Improvement to TDEC calculation for 100GBASE-SR4

Piers Dawe

IEEE P802.3bm, November 2014, San Antonio

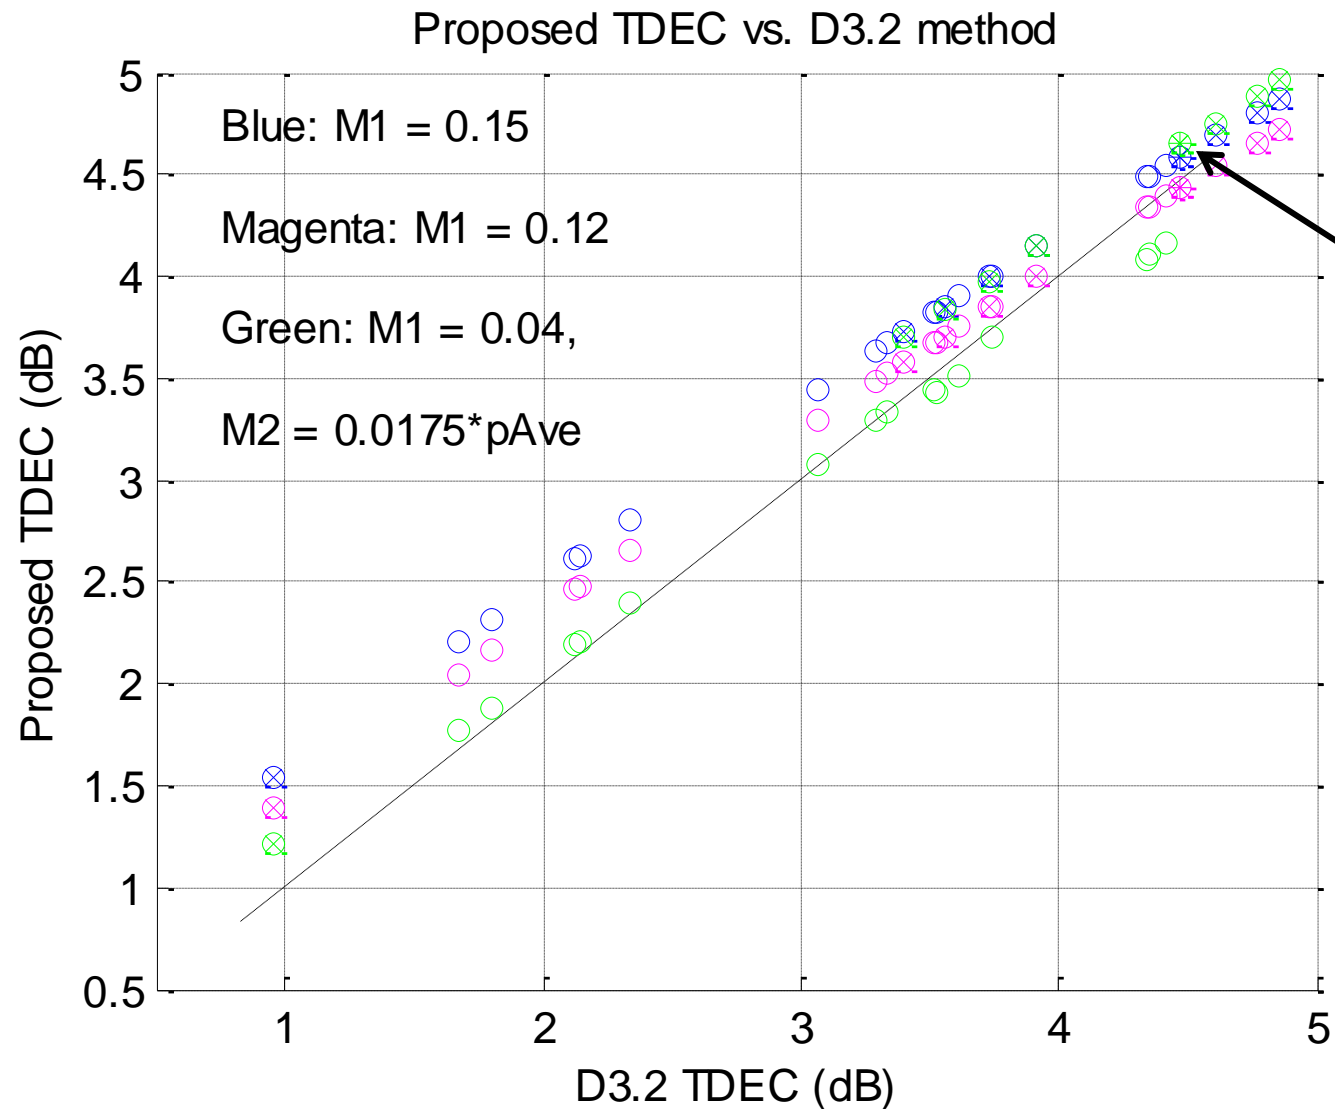
- Three proposals: blue, red and green
 - Green is most recent
- Proposed TDECs give up to 1/2 dB less credit to a good transmitter
 - Closing the budget gap of slide 2
- Blue line crosses black 1:1 line at 4.9 dB
 - Max TDEC in D3.2
 - $M1 = 0.15$
- Red line crosses black 1:1 line at 4.3 dB
 - Proposed max TDEC, comment 11
 - $M1 = 0.12$
- Green lines treat modal noise correctly, as *ModalNoiseIn100GBASE-SR4v3a_mmf*, and treat mode partition noise like the link model spreadsheet does

- $M1 = 0.15$ for max. TDEC = 4.9 dB,
- $M1 = 0.12$ dB for max. TDEC = 4.3 dB

TDEC against simulated link penalty

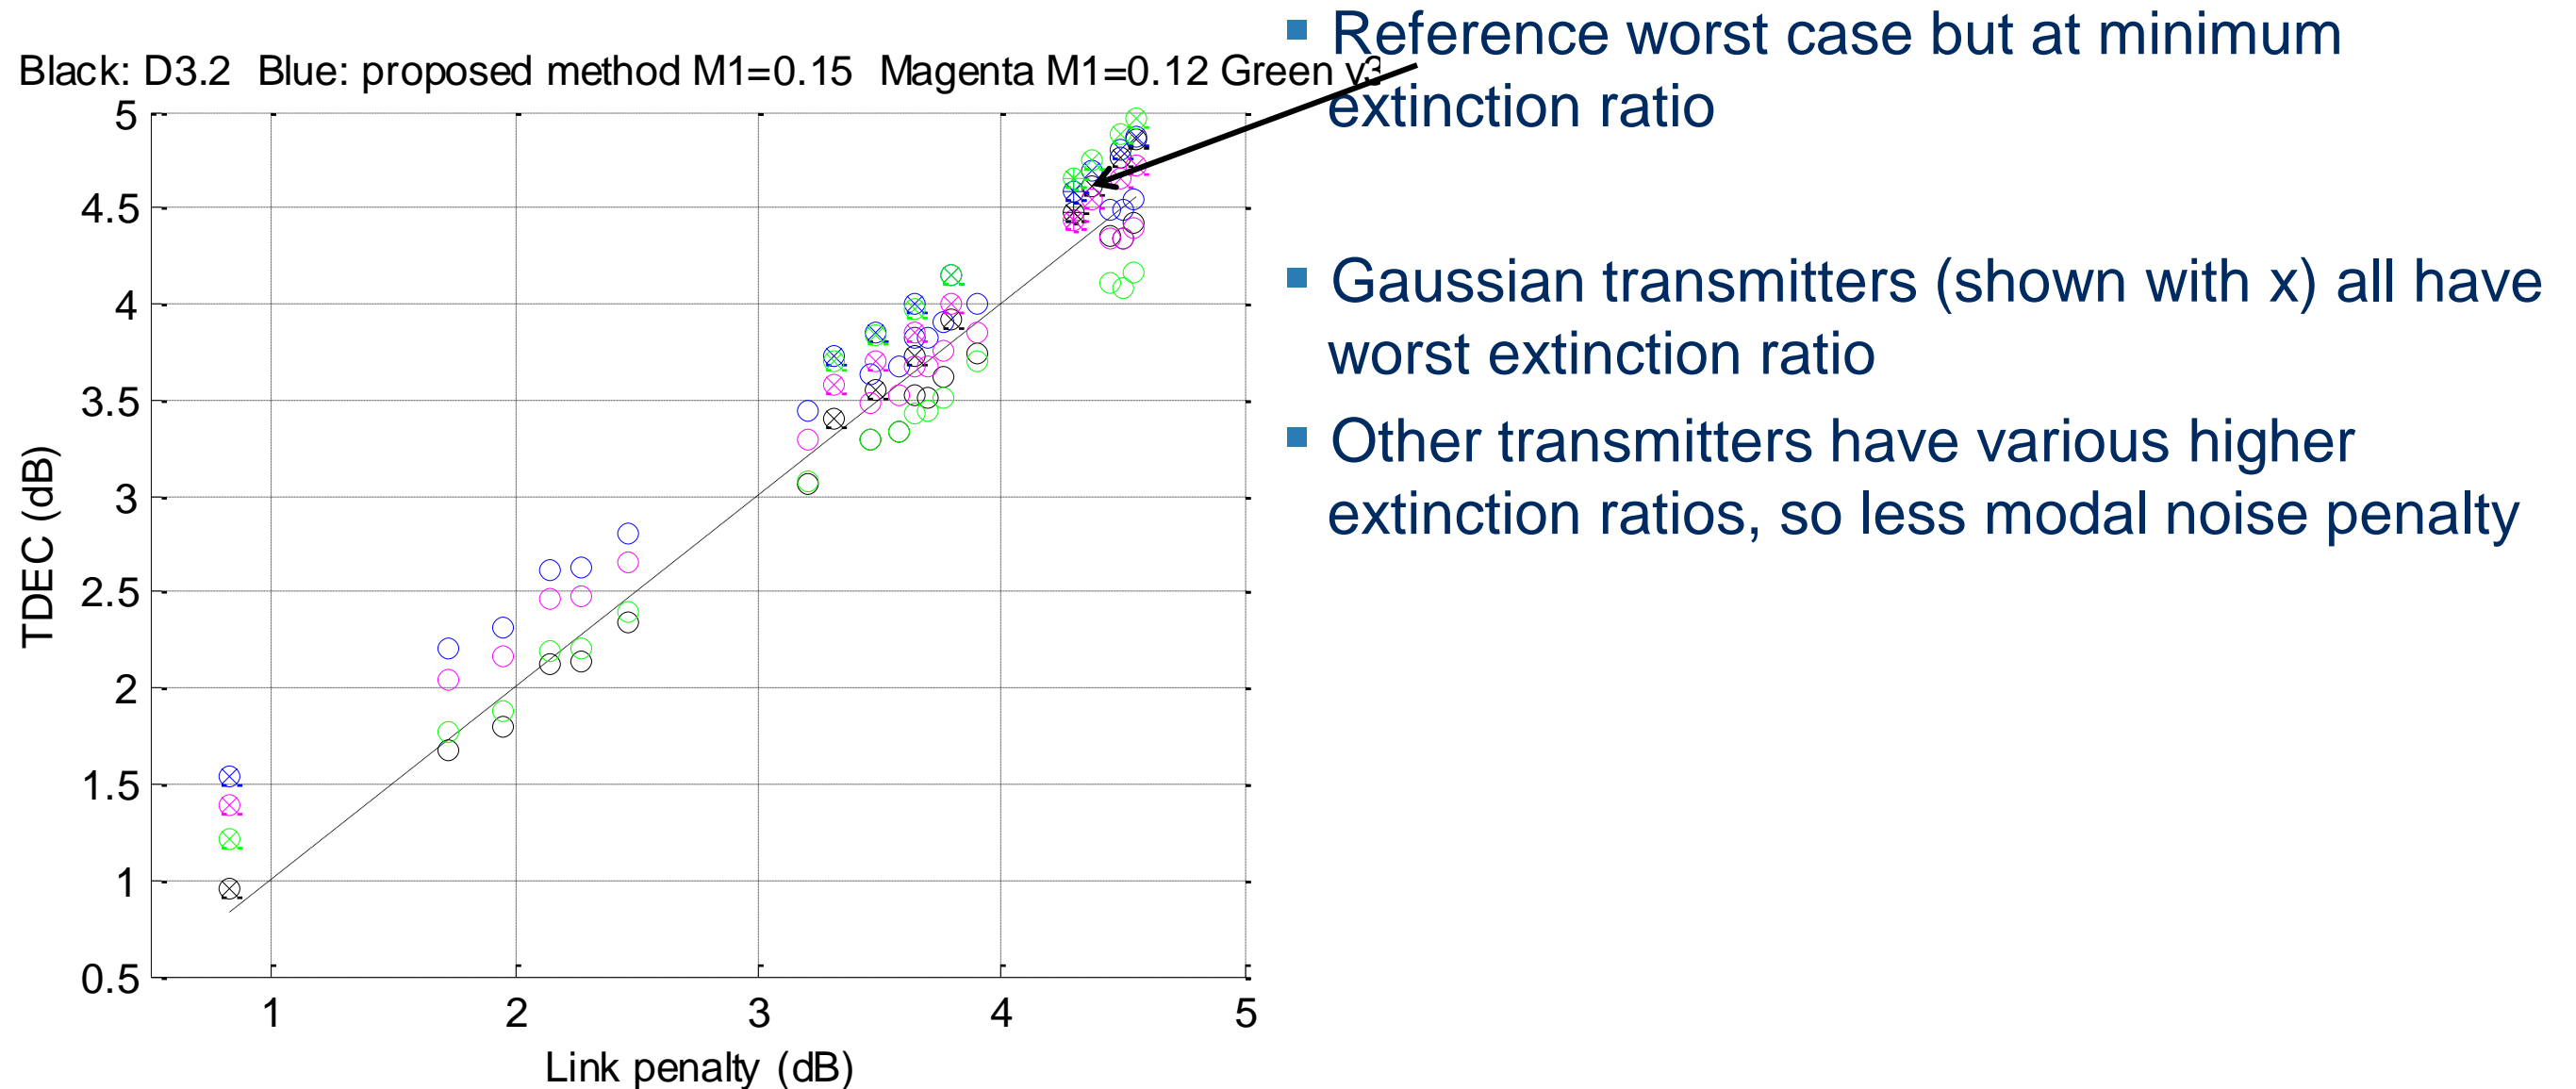
- Reference worst case but at minimum extinction ratio
- Gaussian transmitters (shown with x) all have worst extinction ratio
- Other transmitters have various higher extinction ratios, so less modal noise penalty
